Office Action Summary

10/082,492

MICHAEL J. ARAJ

DETAILED ACTION

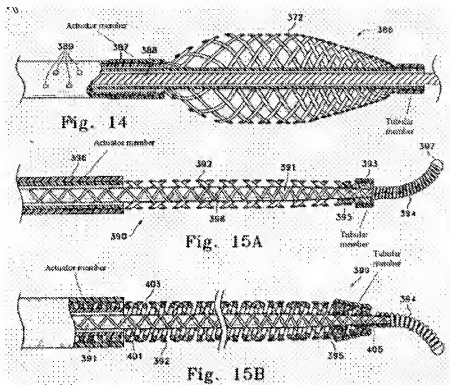
Engelson et al. disclose a device comprising a core wire, e.g. 388 01- 391 with a coil tip coupled to a distal end of the core wire (see for example Figures 14, 15A, 15B). The device further comprises a cage, e.g. 372 or 392. The cage has a distal end, proximal end, first deployment shape, and a second expanded shape. The first and second shapes are different from each other. The device further has a tubular member (see Figures 14, 15A, and 15B) coupled to a distal end of the cage assembly and the tubular member surrounds a distal portion of the core wire proximal to the coil tip.

The device also has an actuator member, as shown above, that has a first position and a second position, and is located proximally to the cage and substantially coaxial about the core wire. When the actuator member is in a first position the cage is in a deployment shape and when the actuator member is in the other position, the cage is in the second expanded shape. The core wire is freely moveably axially through the cage assembly (see col.13, lines 43-44). The tubular member can be considered a bushing. The device can further include an inner coil, e.g. 401, surrounding the core wire within the cage assembly. The inner coil inner coil does not pass distally on the core wire. Engelson et al. disclose the claimed invention except for a cage assembly including a proximal cage and a distal cage.

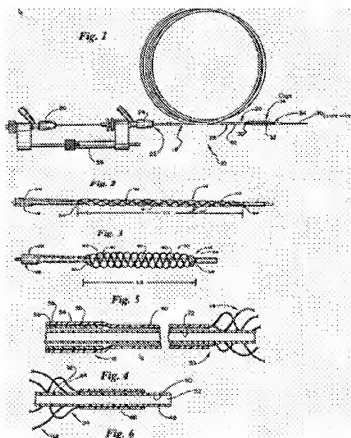
Schmaltz et al. disclose a device comprising a core wire or guidewire 70, a cage 14, a tubular member 46, and an actuator element 18 (see Figures 1-5 below). The cage 14 has a distal end, proximal end, first deployment shape, and second expanded shape, wherein the shapes are different from each other (see Figures 2 and 3 below). The tubular member 46 is coupled to the distal end of the cage assembly and it would surround a distal portion of the core wire or guide wire (see Figures 1 and 6 below). The actuator element has first and second positions and it is located proximal to the cage and it is substantially coaxial about the core wire (see Figure 1). The core wire or guide wire is freely movable axially through the cage (see col. 8, lines 30-35). The core wire or guidewire may be a standard guidewire. The tubular member is considered a bushing and is made of a thermoplastic material, e.g. polyolefin (see col. 7, lines 15-17). The

device further includes inner coils or bands, e.g. 40 and 41, made from radiopaque materials (see col. 6, lines 32-34 and 59-64). The inner coils or bands do not pass distally on the core wire.
